PREVOST

WARRANTY BULLETIN

WB13-91A

DATE :	NOVEMBER 2013	SECTION :	23 - Accessories
EXPIRATION:	NOVEMBER 2015		
SUBJECT :	WIPER MOTOR REPLACEMENT

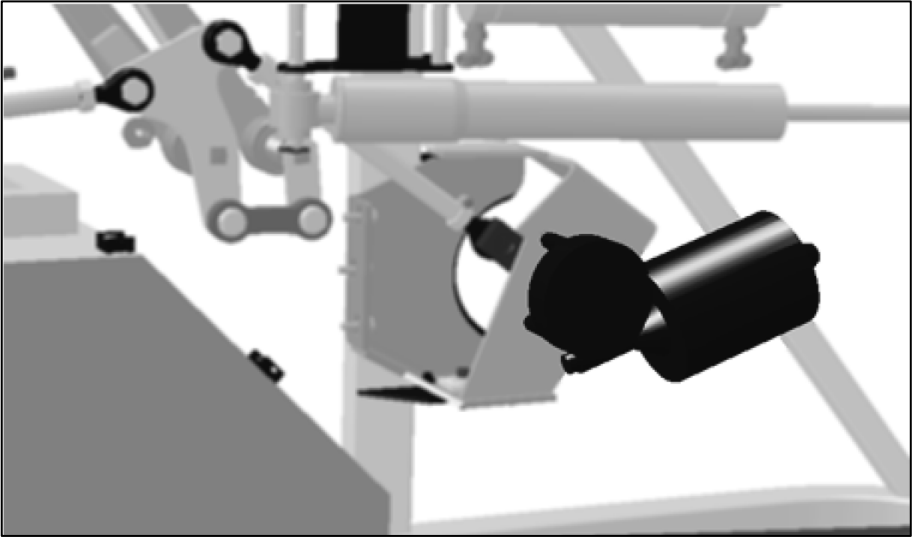
2. Remove multiplex modules A47 & A48 to gain access to the wiper motor assembly.

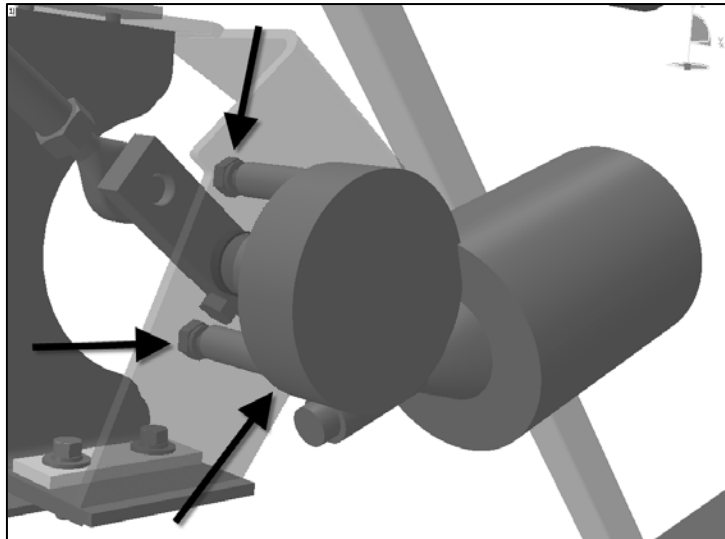
7. Install the new motor with 5001217 M8x20 screws and 5001003 lock washer.

- Assemble with Loctite
- Torque to 22 lbf-ft (dry)

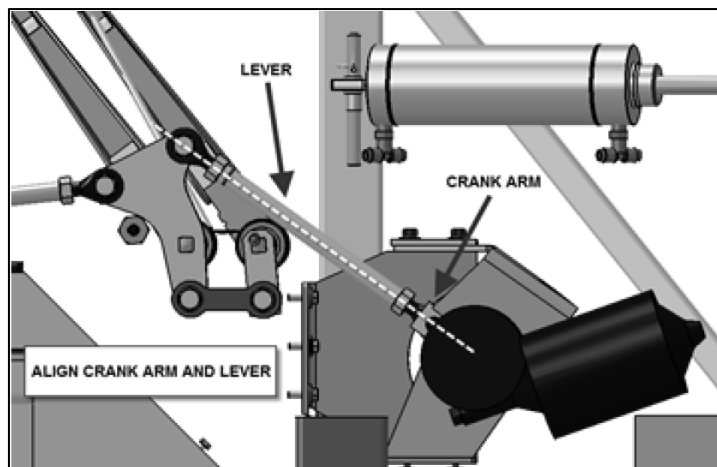
12. Reinstall the crank arm on the motor shaft so that the crank arm and lever axis are aligned as shown, the lever inclined to the left.

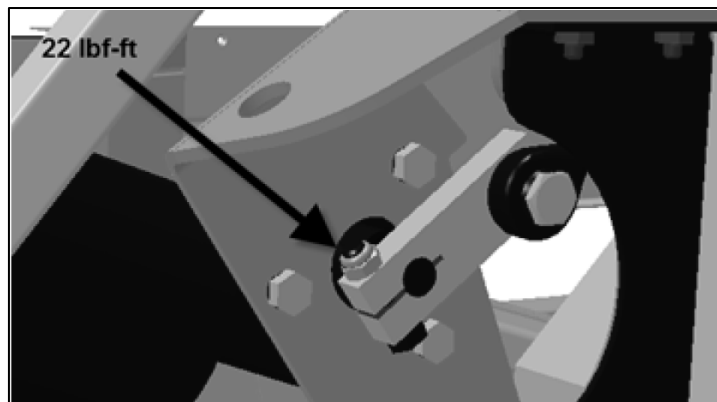
13. Tighten the screw holding the crank arm to the motor shaft.

- Torque to 22 lbf-ft
